Access Compliance Report

Public Rights-of-Way

Intersection ID: 4264	Main Street: MT_HOLLY-HUNTERSVILLE_RD	Cross Street: OVERLOOK_MOUNTAIN_DR	Location: NW
ADA ID: 2F52C63A75E2	Ramp Type: Perp	Initial Pass/Fail: Fail	Overall Compliance: No
Codes/Mitigation Info/Possible Solution		Field Measurements/Component Compliance	
Severity Score: 26.25

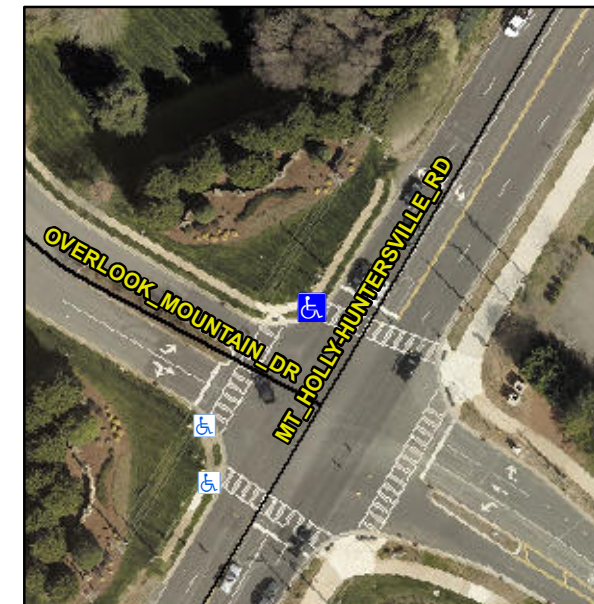
R304.2.2, R304.5.3

Compliance	Description	Data	Compliance	Description	Data
N/A	Ramp Length (in)	51.0	No	Ramp Slope (%)	12.7
Yes	Ramp Width (in)	48.0	No	Ramp XSlope (%)	2.2
N/A	Flare Type LT	N/A	N/A	Flare Type RT	N/A
N/A	Flare Slope LT (%)	N/A	N/A	Flare Slope RT (%)	N/A
N/A	Flare Traversable LT?	N/A	N/A	Flare Traversable RT?	N/A
N/A	Landing Length (in)	N/A	N/A	DWS Provided?	N/A
N/A	Landing Width (in)	N/A	N/A	DWS Contrast?	N/A
N/A	Landing Slope (%)	N/A	N/A	DWS Length (in)	N/A
N/A	Landing X Slope (%)	N/A	N/A	DWS Full Width?	N/A
N/A	Landing Curb? (Y/N)	N/A	N/A	DWS Offset (in)	N/A
N/A	Shared Landing?	N/A			
N/A	Gutter Ponding?	N/A	N/A	Gutter Slope (%)	N/A
N/A	Gutter Lip Ht (in)	N/A	N/A	Gutter X Slope (%)	N/A
N/A	Painted X Walk1?	No	N/A	Painted X Walk2?	N/A
	X Walk 1 Direction	To SW		X Walk 2 Direction	N/A
N/A	X Walk 1 Width (in)	N/A	N/A	X Walk 2 Width (in)	N/A
	X Walk 1 Slope (%)	1.3		X Walk 2 Slope (%)	N/A
	X Walk 1 X Slope (%)	3.2		X Walk 2 X Slope (%)	N/A

Remove & Replace Entire Ramp.
